Environmental Assessment Addendum

Replacement Flows Project – River–
flat Eucalypt Forest area near the
Quakers Hill concentrate storage pond

September 2008

Figure 3.8 from EA

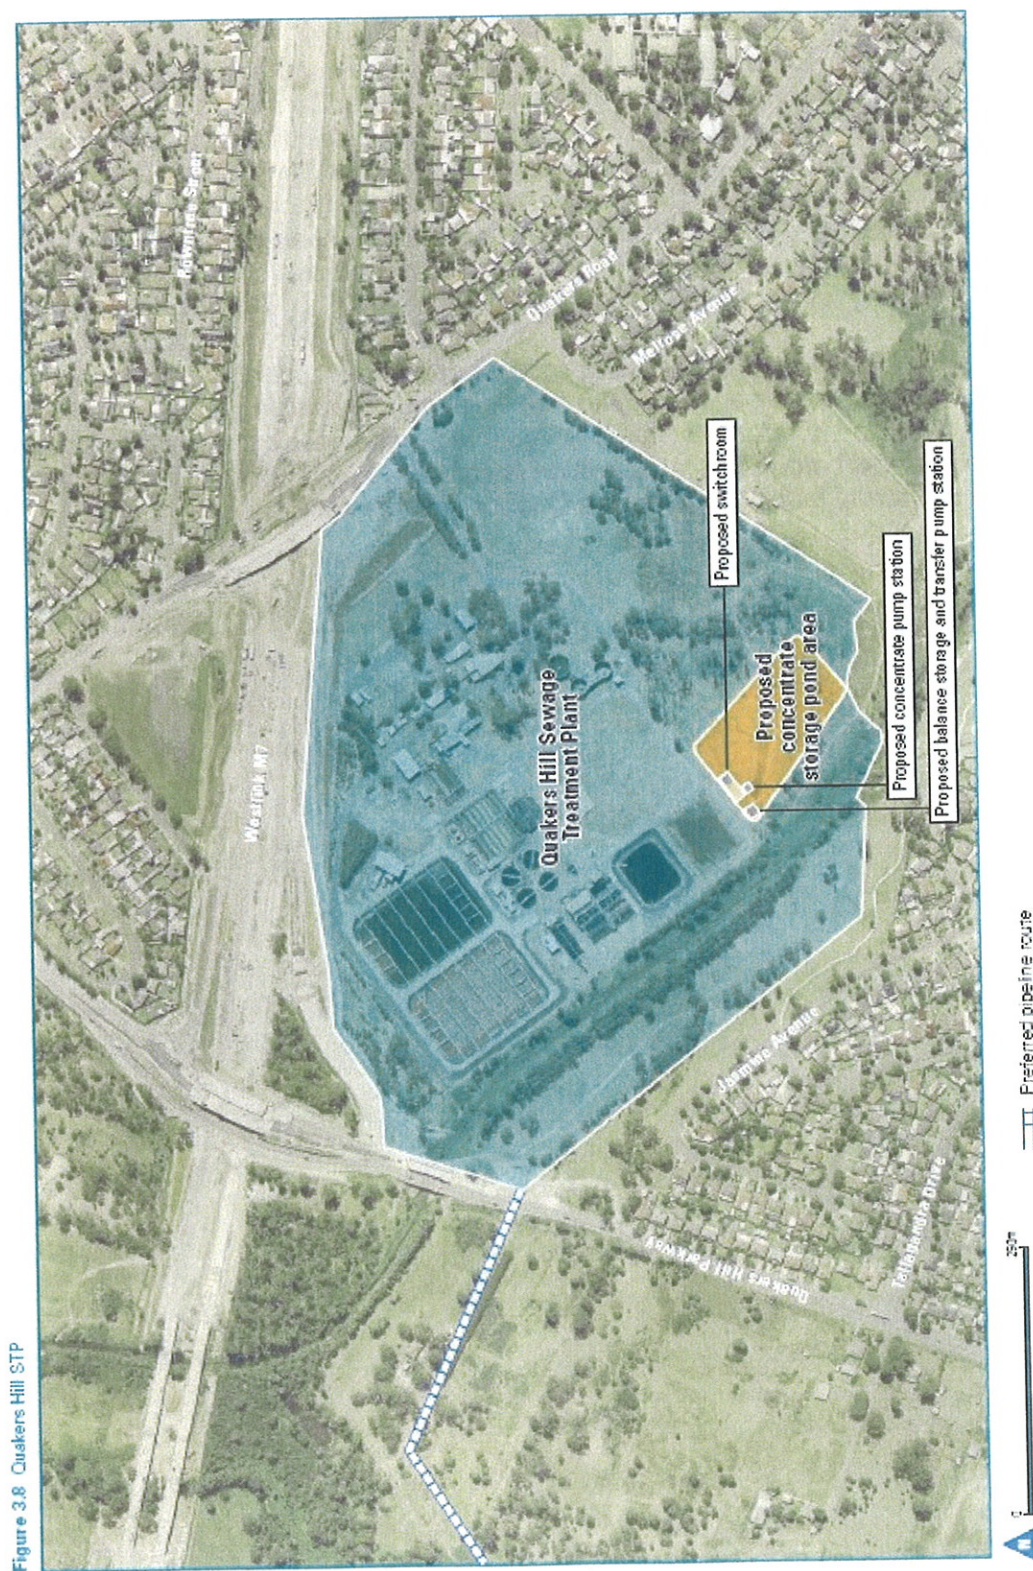
The original location for the concentrate storage pond at Quakers Hill STP is illustrated in Figure 3.8 of the EA (extract below) and described in Section 3.6.1 of the EA:

"A storage pond with a capacity up to 25 ML would be constructed at Quakers Hill STP. The storage pond would be used to provide storage for concentrate in the event that discharge to the NSOOS is not possible during periods of extended wet weather. Operation of the AWTP would be reduced or possibly stopped if the capacity of the storage pond were to be exceeded."

The EA (Section 8.2.3) indicates that there would be minor impacts on vegetation as a result of the clearing for construction of the concentrate storage pond. The EA states that this would be limited to impacts on isolated trees or small stands or regrowth within predominantly cleared areas. The EA does not specify any impacts on endangered ecological communities or threatened species as a result of the construction of the concentrate storage pond.

Figure 2 Revised concentrate pond layout

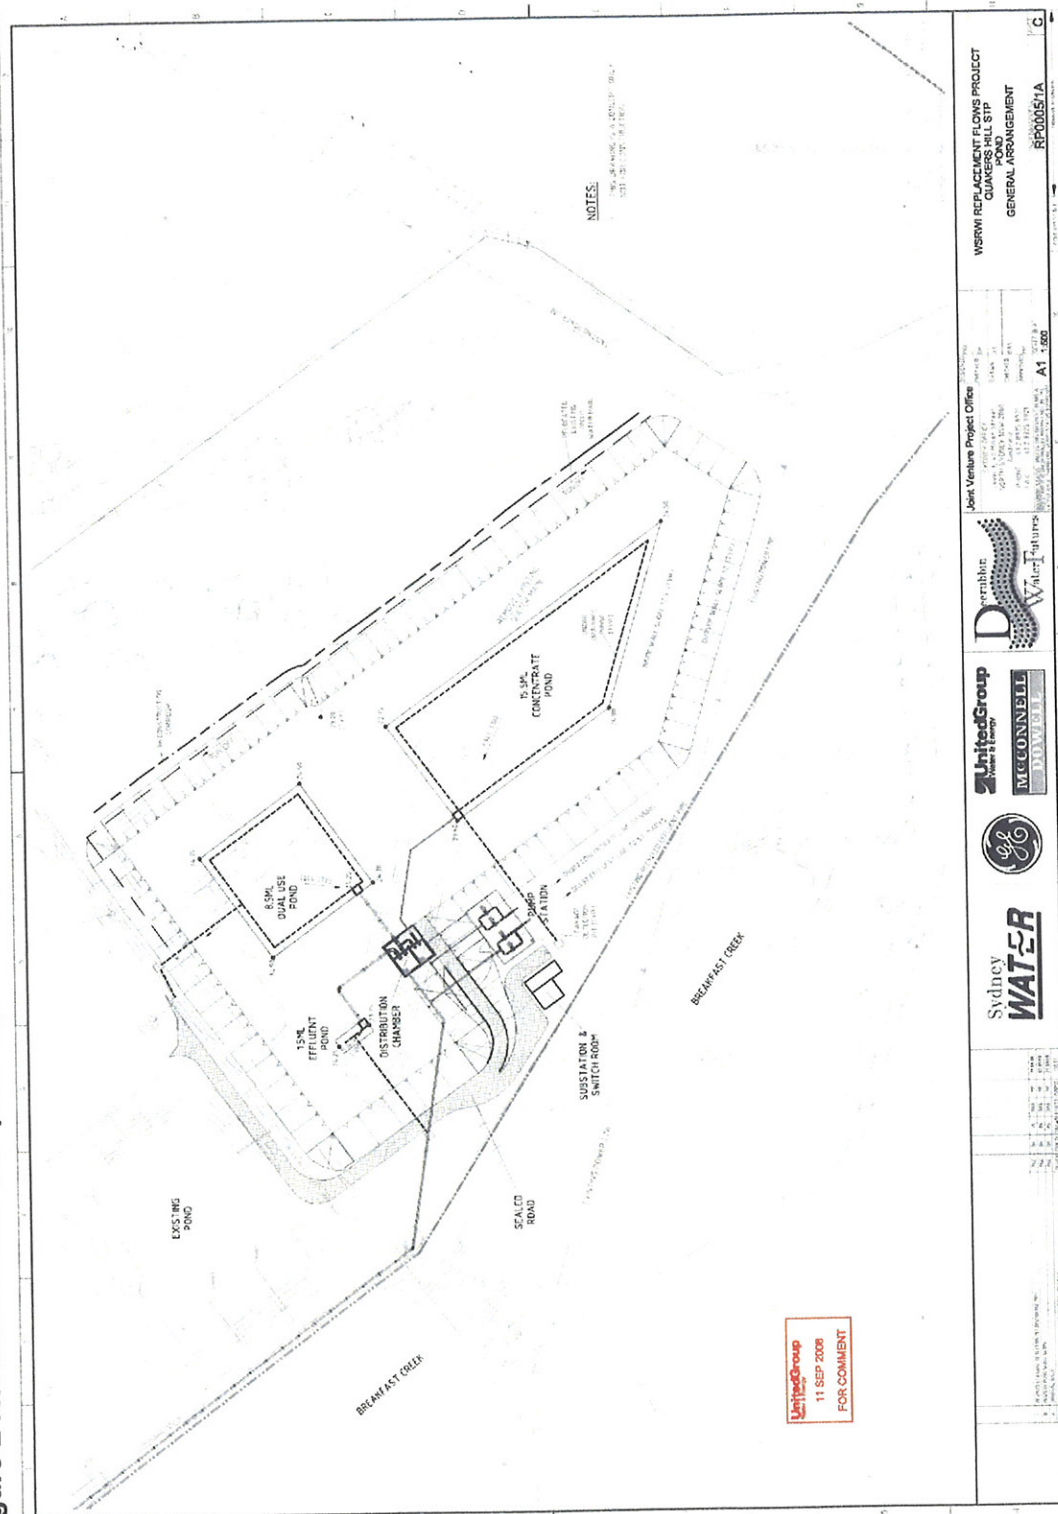
The EA described the concentrate pond as being excavated into the Quakers Hill STP site, requiring the excavation of 40,000 m³ (loose) of spoil. Due to the site conditions, the revised concentrate storage pond will be constructed above ground as discussed in Section 3.

This means that approximately 80,000 tonnes of crushed sandstone virgin excavated natural material (VENM)) will be imported to create a base for the pond. The pond walls would be constructed as 2:1 batters and would stand approximately 5 m aboveground.

The footprint of the revised concentrate storage pond would be 21,400 m² and the layout would be as shown in Figure 2.

4,000 m² of River-Flat Eucalypt Forest would need to be cleared for the construction of the revised concentrate storage pond. 3,800 m² of degraded, weed infested groundcover would also need to be cleared.

The construction and operation of the revised pond will not impact on the Cumberland Plain Woodland Community to the north of the site and there will be a 10 m buffer to the banks of Breakfast Creek to the south. A 4-5 m working distance from the high voltage powerlines would be maintained to ensure construction and operations are within the TransGrid requirement for a 3 m distance from work or plant.
